## **Technical Service Bulletin**

MODEL(S) AFFECTED: T12 Rider Scrubber

SUBJECT: Defective squeegee guide blocks. These parts may contain a void which will weaken the structure,

Cut-away view of defective block

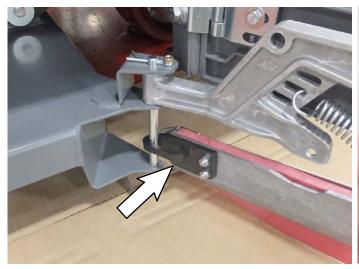
making it prone to breaking when side squeegee door is opened.

PURPOSE: If you have existing stock of part numbers 1201455 and 1200689, please scrap and order new

replacement parts. All Tennant inventory has been replaced with quality parts.
